Access Compliance Report

Public Rights-of-Way

(Curb Ramps)

Intersection ID: 28312	Main Street: KRISHNA_LN	Cross Street: OLD_ARDREY_KELL_RD	Location: NW
ADA ID: B5C084F2F8E4	Ramp Type: PerpDiag	Initial Pass/Fail: Fail	Overall Compliance: No
		Severity Score: 12.5

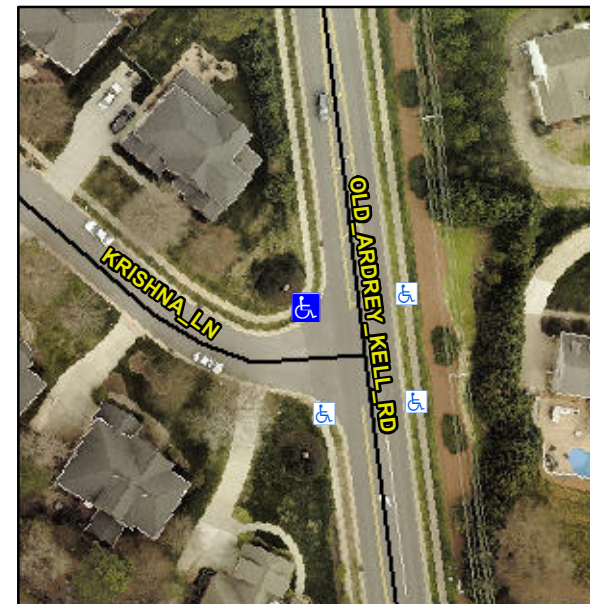
Not Found, R304.2.2

Compliance	Description	Data	Compliance	Description	Data
N/A	Ramp Length (in)	47.5	No	Ramp Slope (%)	9.4
Yes	Ramp Width (in)	50.0	Yes	Ramp XSlope (%)	1.4
N/A	Flare Type LT	N/A	N/A	Flare Type RT	N/A
N/A	Flare Slope LT (%)	N/A	N/A	Flare Slope RT (%)	N/A
N/A	Flare Traversable LT?	N/A	N/A	Flare Traversable RT?	N/A
N/A	Landing Length (in)	N/A	N/A	DWS Provided?	N/A
N/A	Landing Width (in)	N/A	N/A	DWS Contrast?	N/A
N/A	Landing Slope (%)	N/A	N/A	DWS Length (in)	N/A
N/A	Landing X Slope (%)	N/A	N/A	DWS Full Width?	N/A
N/A	Landing Curb? (Y/N)	N/A	N/A	DWS Offset (in)	N/A
N/A	Shared Landing?	N/A			
N/A	Gutter Ponding?	N/A	N/A	Gutter Slope (%)	N/A
N/A	Gutter Lip Ht (in)	N/A	N/A	Gutter X Slope (%)	N/A
N/A	Painted X Walk1?	No	N/A	Painted X Walk2?	No
	X Walk 1 Direction	To S		X Walk 2 Direction	To E
N/A	X Walk 1 Width (in)	N/A	N/A	X Walk 2 Width (in)	N/A
	X Walk 1 Slope (%)	0.2		X Walk 2 Slope (%)	0.3
	X Walk 1 X Slope (%)	0.3		X Walk 2 X Slope (%)	2.3

Remove & Replace Curb Ramp With Two New Directional Ramps or Equivalent.
